Planning Commission Staff Report

SUBJECT: D22-64 BBQ ISLAND

The applicant is proposing the development of a warehouse use on Lots 39 and 40 in Elliot Commerce Park located at the southwest corner of William Dillard Drive and Elliot Road within the Northwest Growth Area.

PRELIMINARY GRADING COVER SHEET

PRELIMINARY GRADING AND DRAINAGE
FOR
BBQ ISLAND
1948 W. SIERRA MADRE AVENUE
GILBERT, ARIZONA

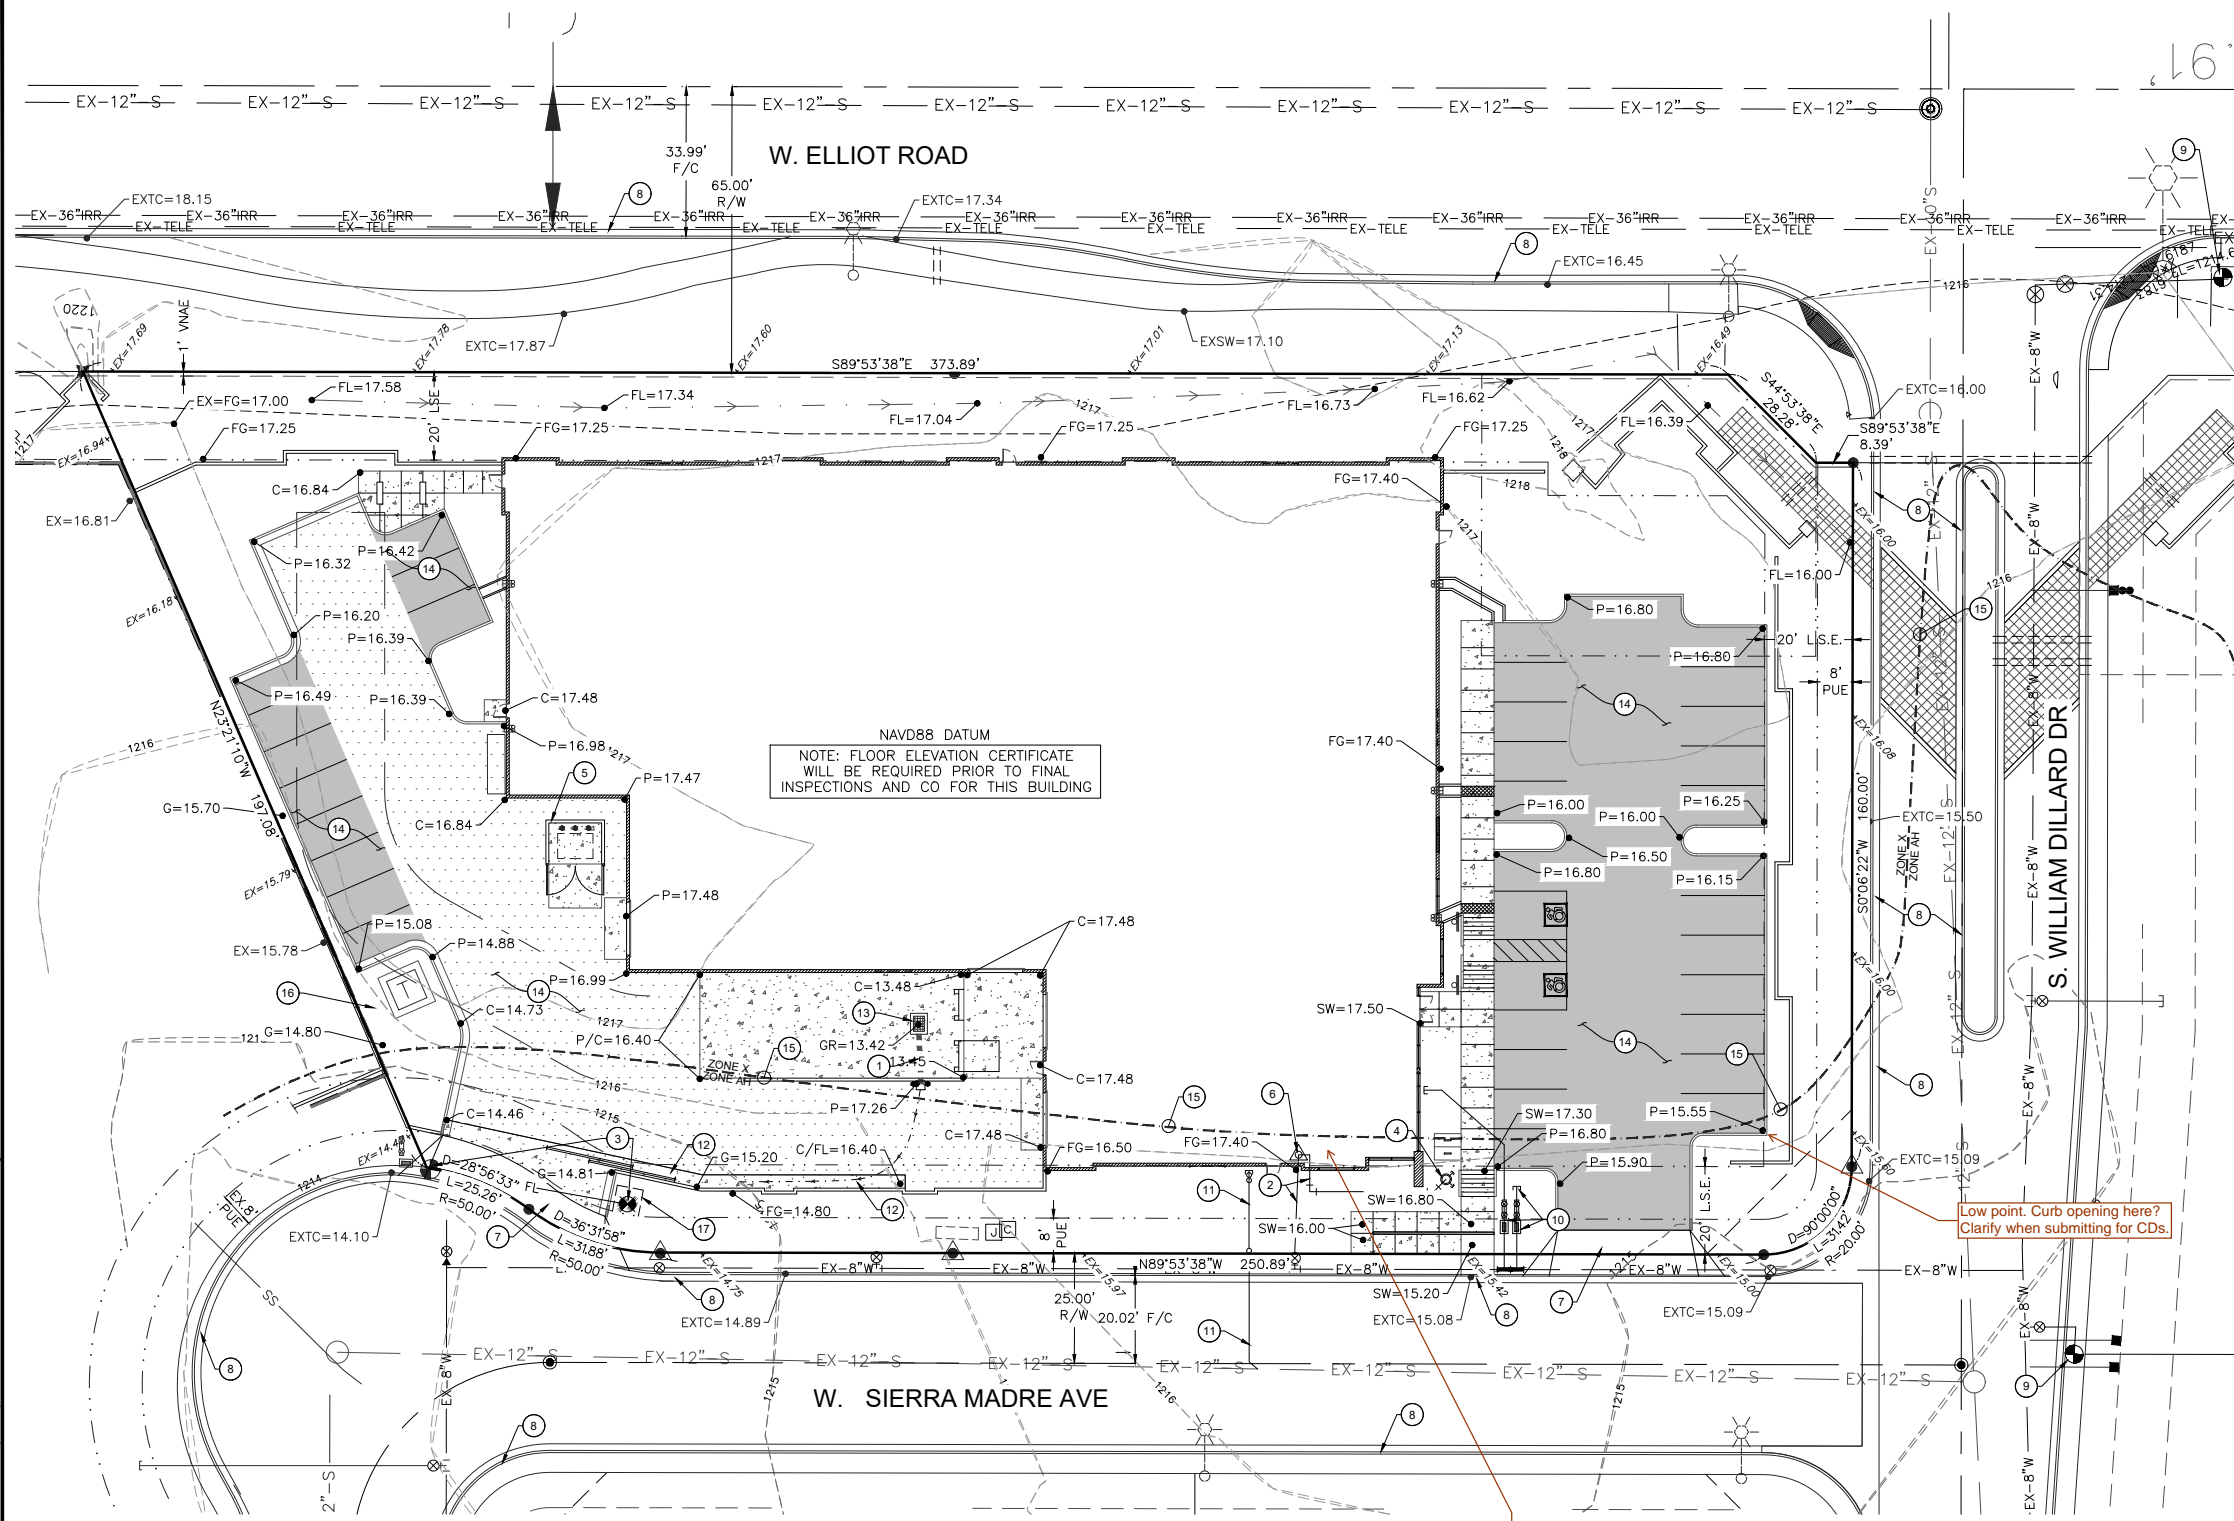
Low point. Curb opening here?
Clarify when submitting for CDs.

Reference in Drainage Report how runoff from the compensatory storage will be handled at permitting. Also, verify and reference the regional basin having the capacity for the compensatory volume
